Form 3160-5 (August 2007)				FORM APPROVED OMB NO. 1004-0135 Expires: July 31, 2010	
SUNDRY NOTICES AND REPORTS ON WELLS			5. Lease Serial No. NMNM15429	5. Lease Serial No. NMNM15429	
Do not use this form for proposals to drill or to re-enter an abandoned well. Use form 3160-3 (APD) for such proposals.			6. If Indian, Allottee of	6. If Indian, Allottee or Tribe Name	
SUBMIT IN TRIPLICATE - Other instructions on reverse side.			7. If Unit or CA/Agre NMNM104038	7. If Unit or CA/Agreement, Name and/or No. NMNM104038

1. Type of Well Other			8. Well Name and No. OXY THOR FEDERAL 1		
2. Name of Operator OXY USA WTP LIMITED	Contact: PTNRSHIP E-Mail: david_stev	DAVID STEWART wart@oxy.com NM OIL CONSERVA 3b. Phone No. (includAgreesgae) Ph: 432-685-5717	9. API Well No. 30-015-29846-00-S1		
3a. Address		3b. Phone No. (includArreside) Ph: 432-685-5717	UNDESIGNAT	Exploratory	
HOUSTON, TX 77210		Ph: 432-685-5717 UN 0 6 2016

OXY USA WTP LP - Current OXY Thor Federal #1 API No. 30-015-29846

Permanent Abandonment of Federal Wells Conditions of Approval

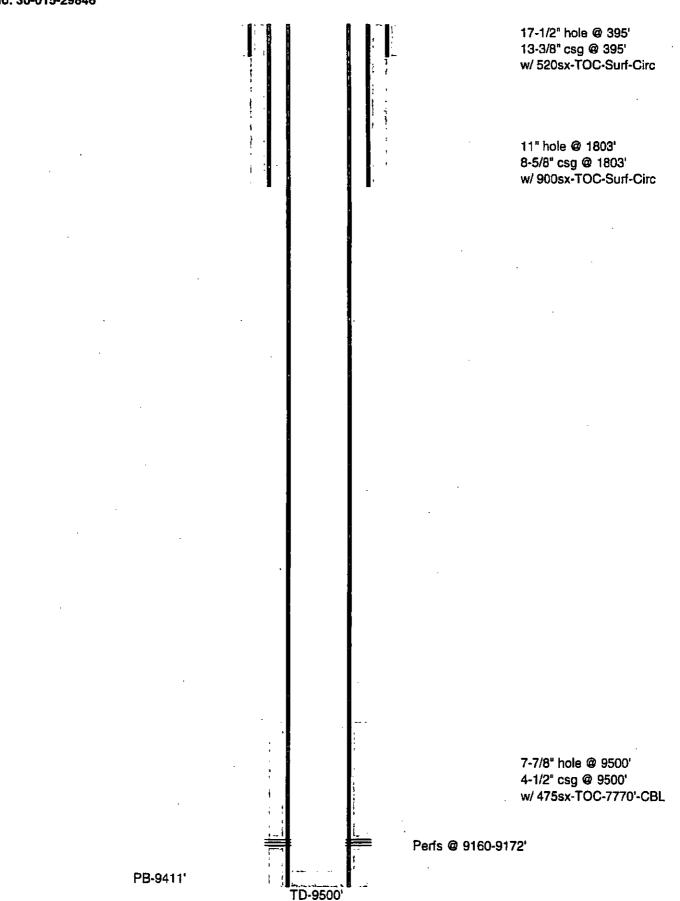
** BLM REVISED **

7. Perf @ 445', sqz 150sx cmt to surface 10# MLF between plugs Above ground steel tanks will be utilized
